GARD response to

Ofwat's Consultation on Draft Ofwat Gate 2 Decision

Volume 1 – Main report and appendices

GARD Review of Draft Ofwat Gate 2 Decisions

Figure 3 - RAPID and GARD quality scores for Abingdon reservoir Gate 2 report

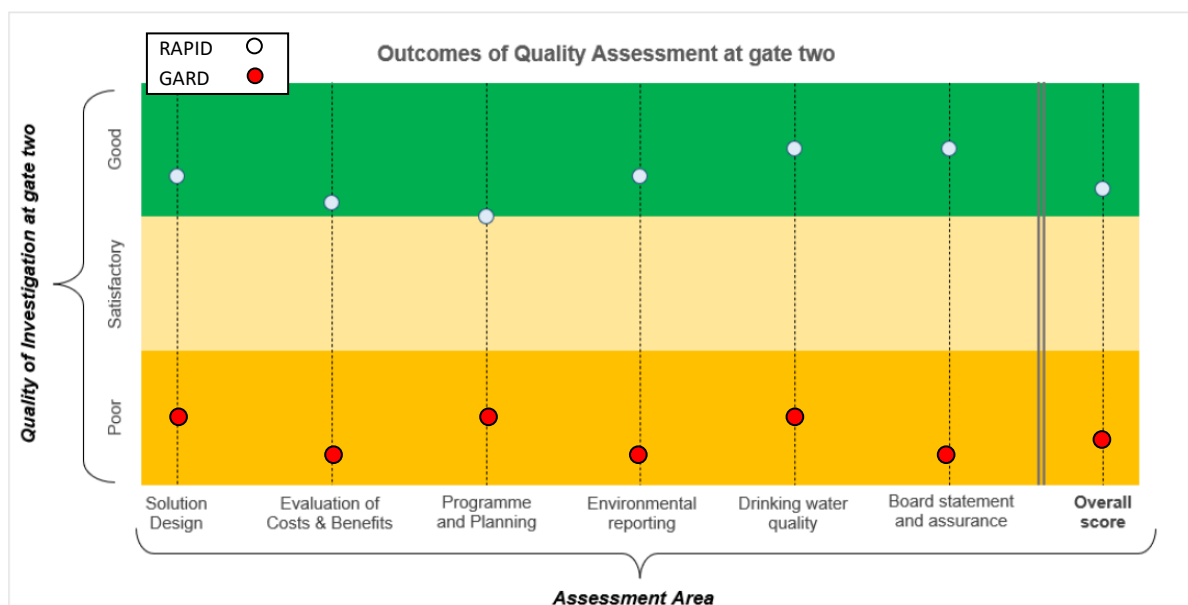
We strongly disagree with Ofwat’s assessment, marking the Gate 2 report as poor in all the assessed categories, as shown in Figure 3. In the following sections, we have provided brief comments on each of these categories, with supporting evidence in Appendices.

Figure 7 - Abingdon reservoir in artificially extended historic 1934 drought

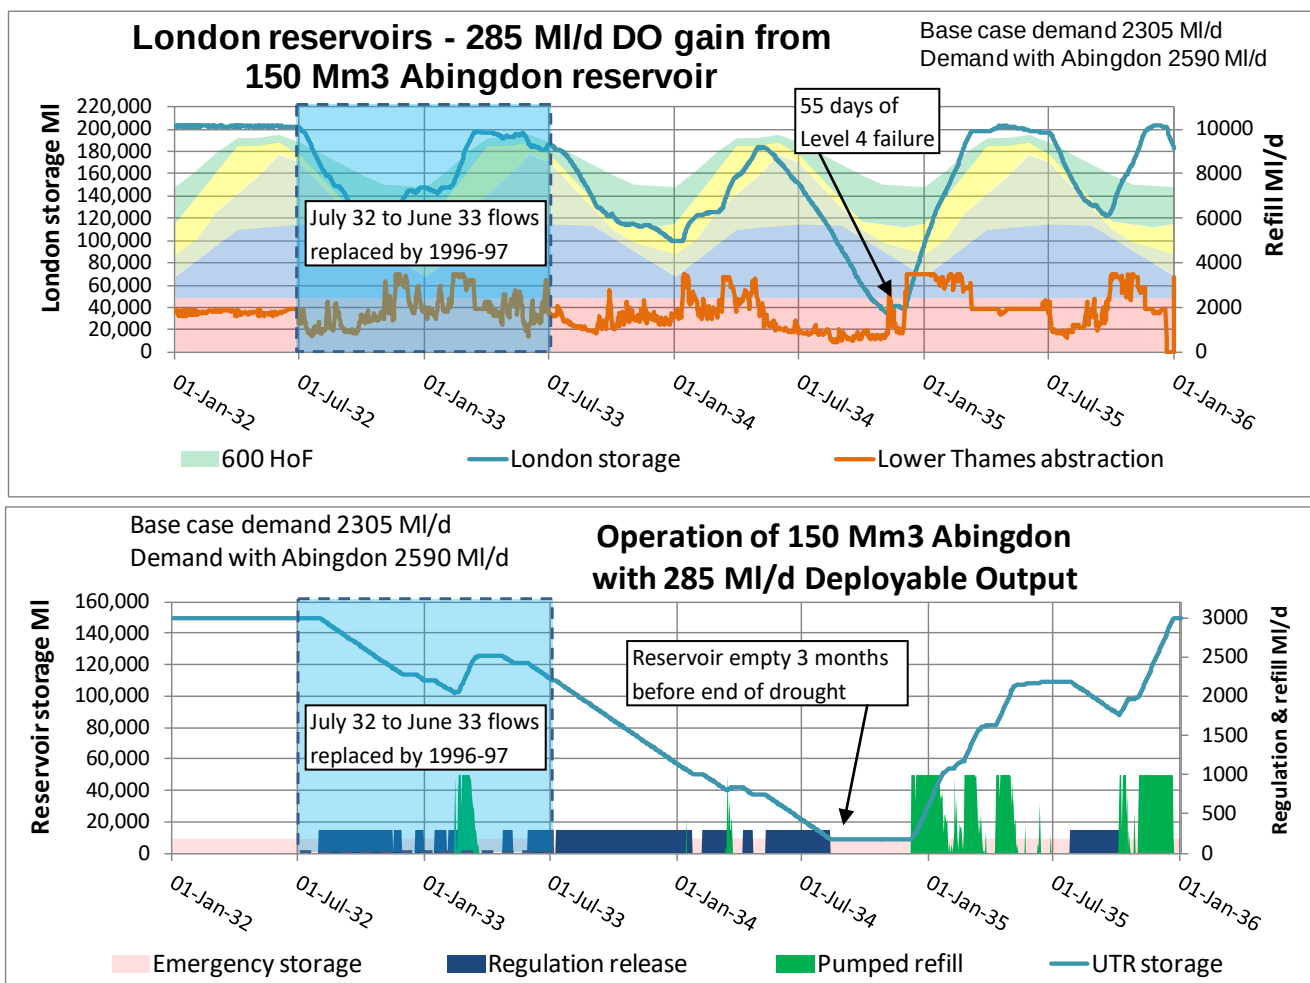
3. However, although the Culham MRF error does not appear to have a big impact on Abingdon reservoir deployable output, it can greatly affect the speed of reservoir refilling after droughts. For some of the relatively few droughts in the stochastic record which are not versions of the 1976 drought, GARD's modelling shows that Abingdon reservoir is less than half full at the start of the next summer and vulnerable to failure if another dry summer follows – similar to the failure shown in Figure 7.

The deployable output of Abingdon reservoir will be a lot less than shown in the table above, perhaps only half these values, when proper consideration has been given to the likelihood of a sequence of dry years which prevent the reservoir from being full at the start of a major drought or delay its refilling after a major drought, as shown by the example in Figure 7.

Figure 8 - Thames Water's pre-construction programme for Abingdon reservoir

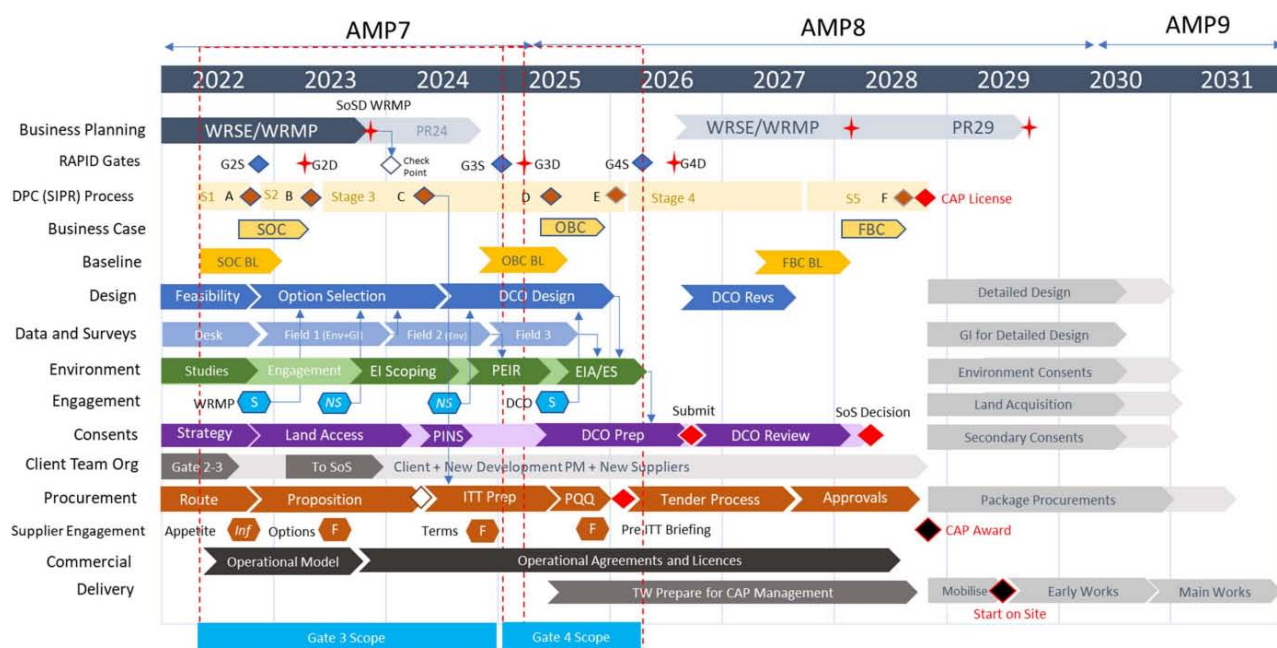
geotechnical investigations, including a trial borrow pit and embankment, before the pre-tender design and the start of the tender process. We can see no evidence of planning of the geotechnical investigations, either in the SESRO Gate 2 reports or on the programme shown in Figure 8.

Figure 11- Proportion of Abingdon reservoir releases in river flow downstream

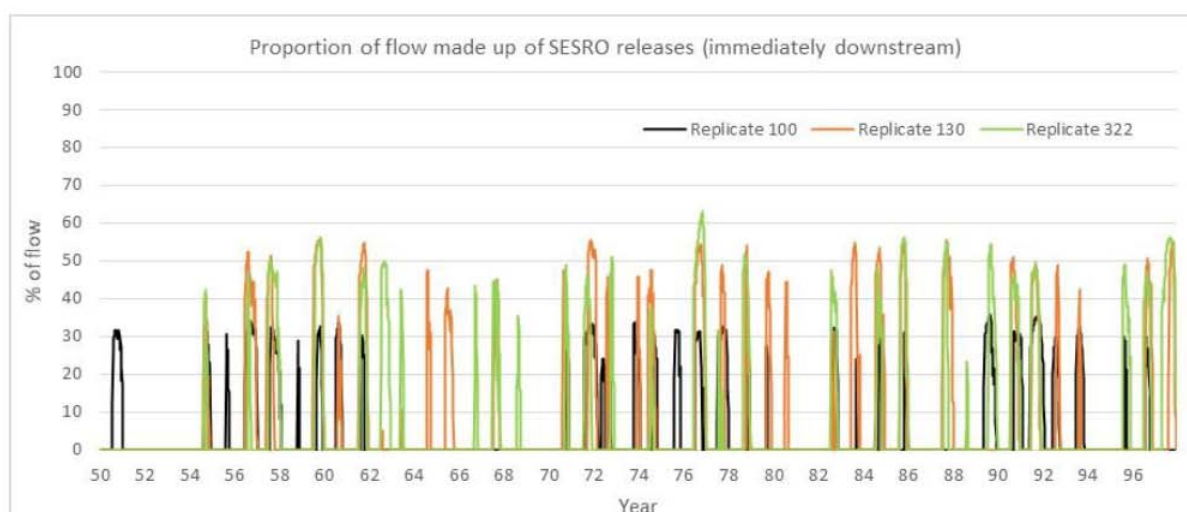
"Although SESRO will modify flows, the bulk of the river flow at most times will continue to be existing natural river flow (Figure 2.2). Even when fully operational, SESRO will rarely make up more than 50% of the flow immediately downstream of the outfall, and this proportion will diminish downstream as tributaries add more flow. Consequently, the water quality risk in the River Thames will for many chemicals remain much the same as before."

Figure 12 - NRFA flow summary for Days Weir flows in 1976 drought

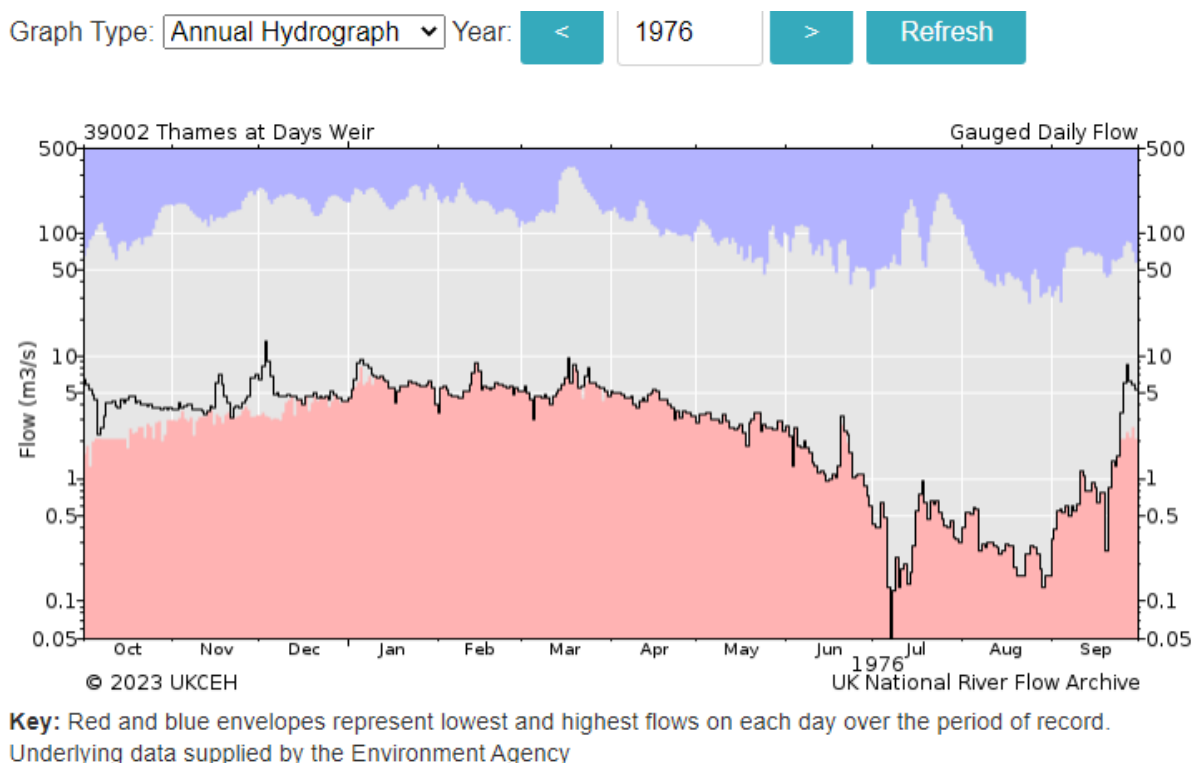
for flows at Days Weir a few kilometres downstream of the reservoir, that for several months in a severe drought a 321 MI/d regulation release from Abingdon reservoir would be a much larger proportion than 50% of the flow at Days Weir:

Figure 13 - RAPID and GARD quality scores for Severn Thames Transfer Gate 2 report

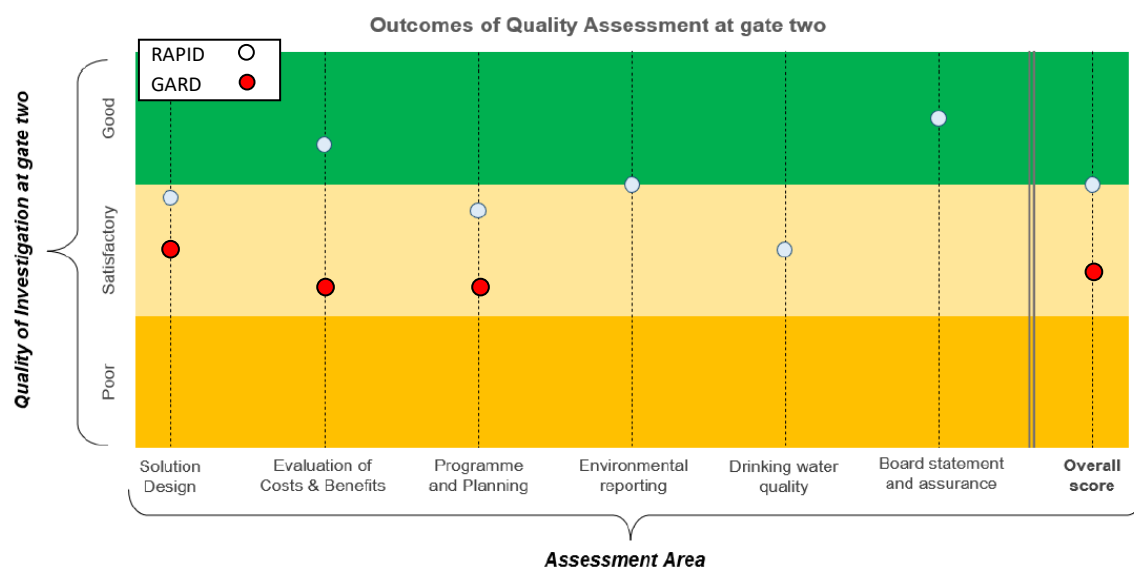
As shown on Figure 13, Ofwat have rated the solution design as ‘Satisfactory’ rather than ‘Good’, explained as follows:

Figure 15 - Operational carbon budgets for STT Deerhurst interconnector options

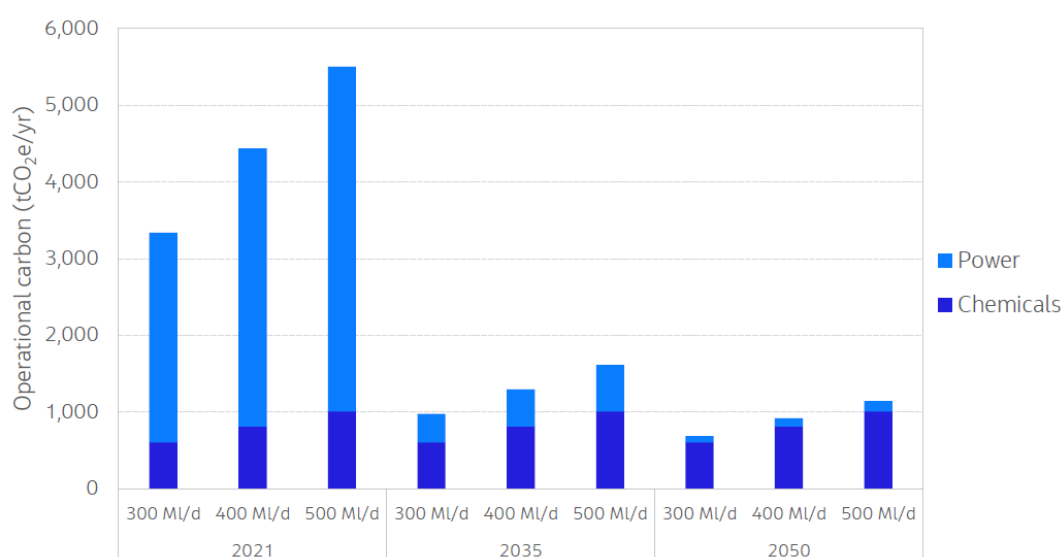
4. The most important problem however, is the **difference in assumed Operational Start date**. This has already been noted as affecting cost comparisons, but as Figure 15 shows, there is a huge difference in Opex carbon if the Deerhurst connector had started operation in 2021, compared to an operational start date of 2035 (the earliest feasible current start date). In fact, this distorts the whole evaluation in the STT Design Report (table 6.2) the Opex carbon for the 300 ML/d Deerhurst option is

quoted as **139,258 tCO₂Eq**. This figure cannot possibly be derived from 70-80 years of operation with the Figure 15 yearly Opex carbon. By 2035 the Opex carbon for Deerhurst is less than 1000 tCO₂eq per annum and reduces to around 600 tCO₂eq by 2050.

Figure 17 - Typical operational use of the 120 MI/d Thames to Southern transfer

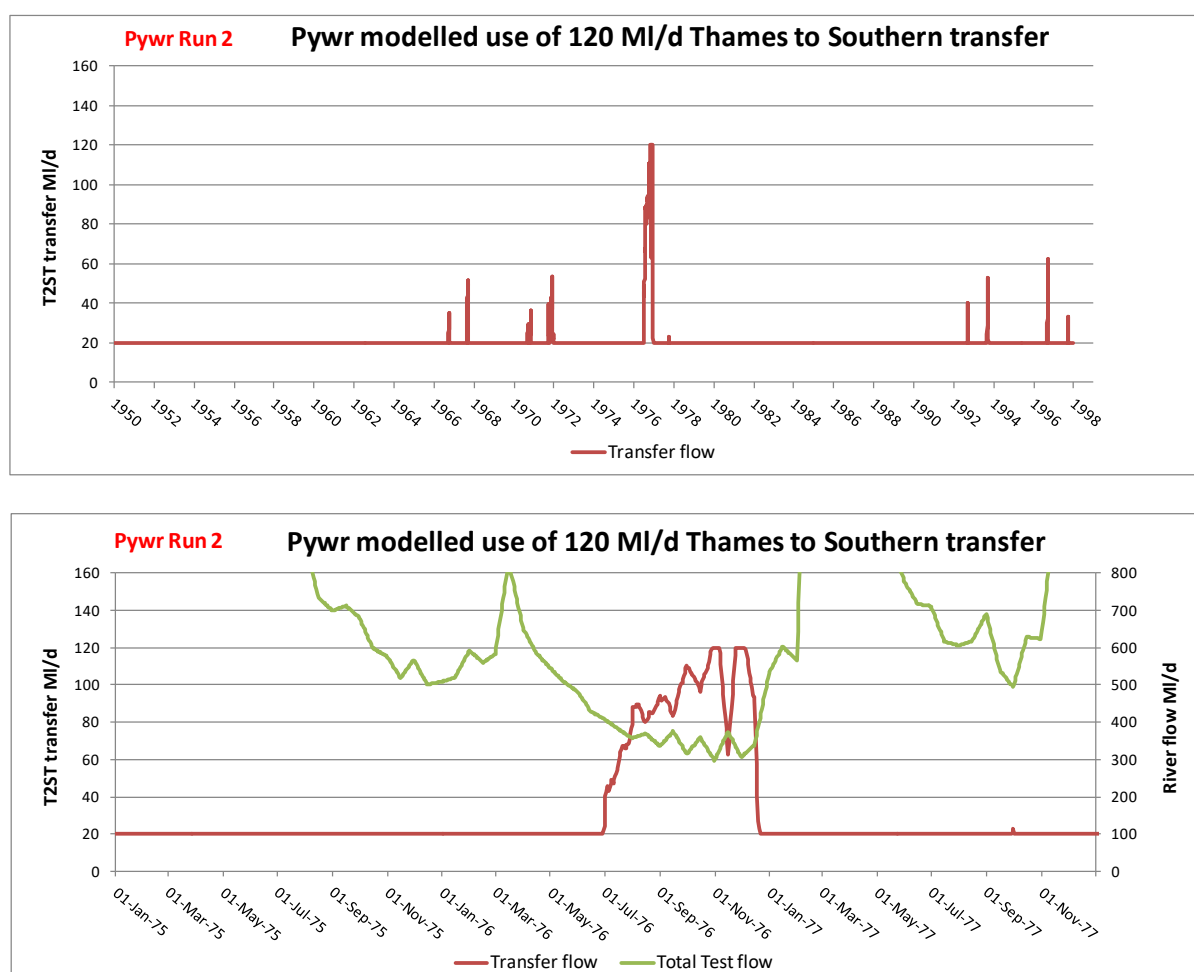
In major drought years, like 1976 in the example shown in the lower plot in Figure 17, the transfer could run for 6 months or more, triggered to comply with a total Test hands-off flow of 355 MI/d, and peaking at the 120 MI/d capacity for short periods. However, although the Pywr modelling shows drought use about once in 5 years on average, usually this will be for a relatively short period and at much less than the 120 MI/d capacity.

The plots in Figure 17 are based on stochastic river flow data. We propose that the credibility of the modelled frequency and amount of usage should be tested by comparison with gauged flow records and historic frequency of triggering the drought permits.

Figure C1 - Population growth assumed in TW's preferred plan

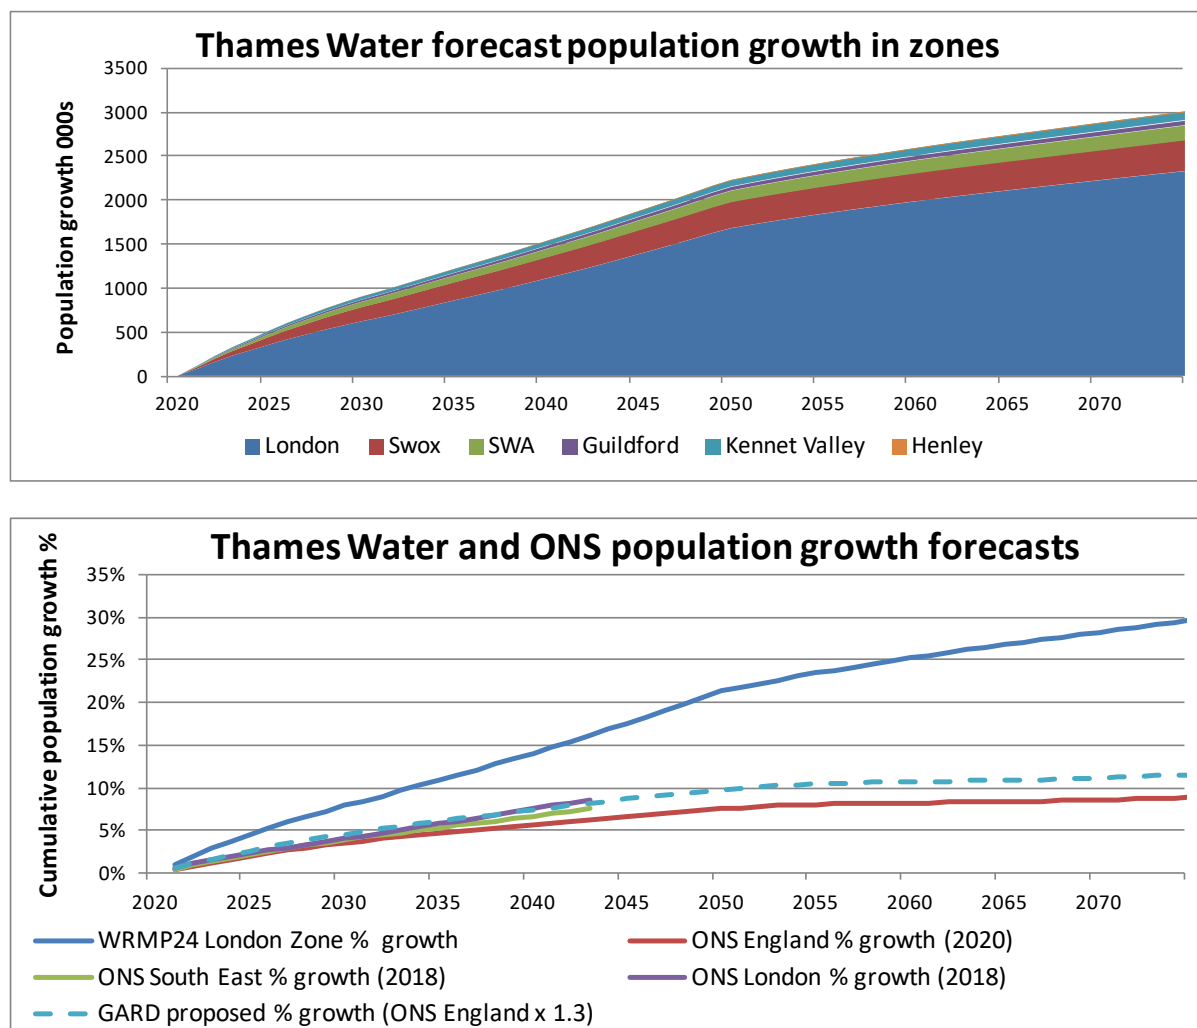
- This is further illustrated at para 3.114 and the accompanying Figure 3-8 where just plan-based and ONS principal projection (now just called ONS Projection) are clearly presented as if they were the upper and lower boundaries of forecasts. If it is valid to consider high scenarios and incorporate them into an adaptive plan, why is it not equally valid to treat low scenarios in the same way (or at least present an argument for not doing so). The adaptive plan eventually presented, being based on the local planning figures, takes no account of even a most likely out-turn, yet alone a low projection. This makes all of the discussion on population in Section 3 rather pointless.

Inspection of para 3.115 and associated Tables 3-12 and 3-13 strongly supports the argument that the plan-based figures should be considered unusable, with the SWOX, SWA, Kennet Valley and Guildford figures clearly vastly inflated with unrealistic growth rates. The SWOX figure in particular looks to be an outlier. Using the ONS 2020 growth rates, the SWOX growth figure is more likely to be around 17% up to 2100 rather than the 40% used in the plan. Using a starting figure of 1,069,000 in 2020 would result in growth to only 1,159,900 by 2050 and 1,250,700 by 2100, a reduction of 209,000 and 243,000 respectively on the WRMP plan. These figures correlate strongly with the slight reduction between ONS 2018 and 2020 updates, and the figures presented at Table 3-13. If TW disagree with this, they should present evidence as to why this area will outgrow the rest of England by more than 100% over the rest of the century.

Figure F2 - Comparison of TW and United Utilities planned urban PCC reductions

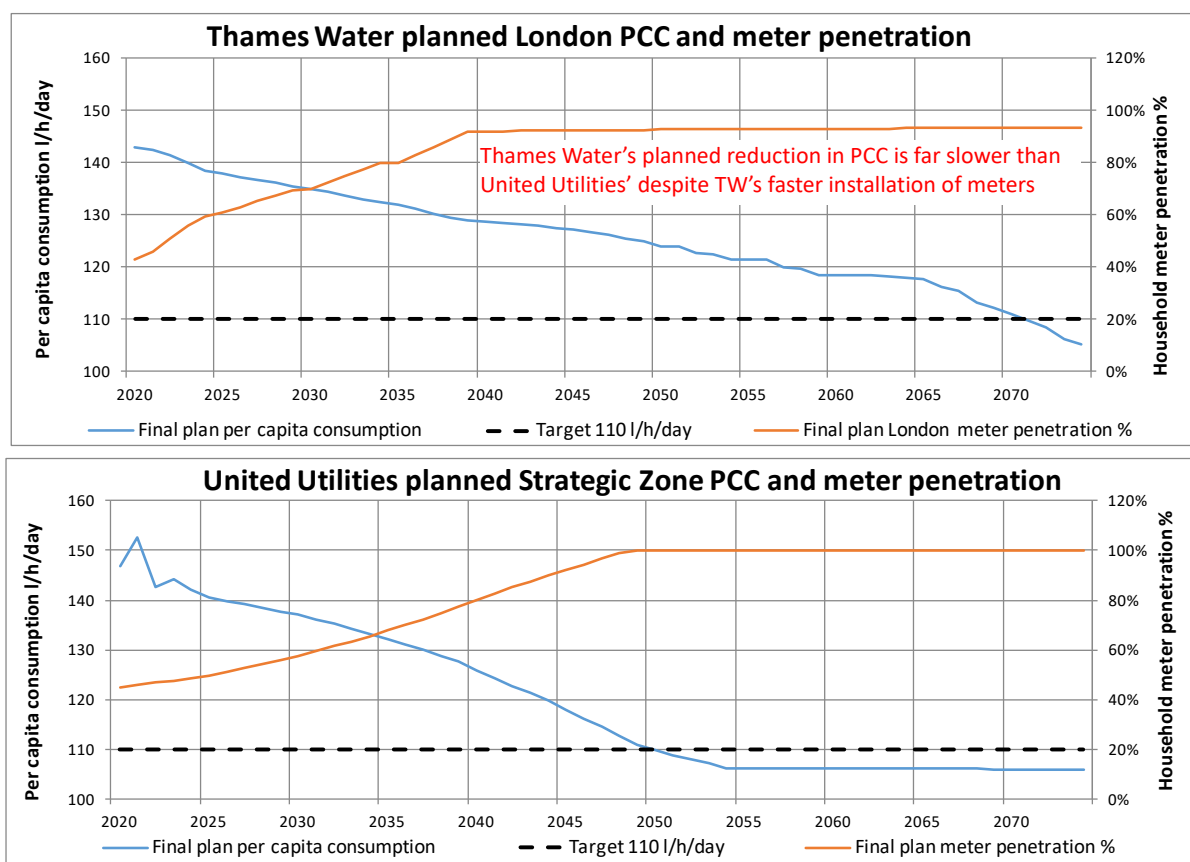
Figure F2 shows a large disparity in the planned achievement of the 110 l/person/day target despite the similarity of the zones in terms of size and urbanisation. United Utilities plan to meet the target by 2050, whereas Thames Water's London PCC is still at 124 l/person/day in 2050, despite planned meter penetration of 90% by 2040.

Figure F3 - Thames Water's planned meter penetration in each zone

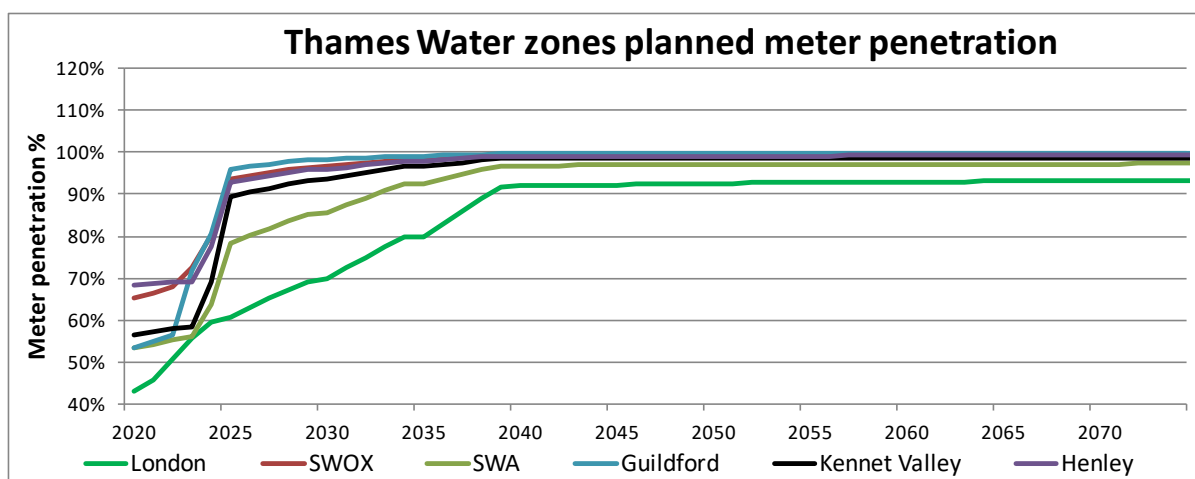
This shows that Thames Water plan near total meter coverage in all zones by 2040, so the forecast failure to meet the 110 l/p/day target by 2050 seems unduly pessimistic. If TW say the target can be met in every zone by 2075, as shown in Figure 18, why can't this be achieved by 2050?
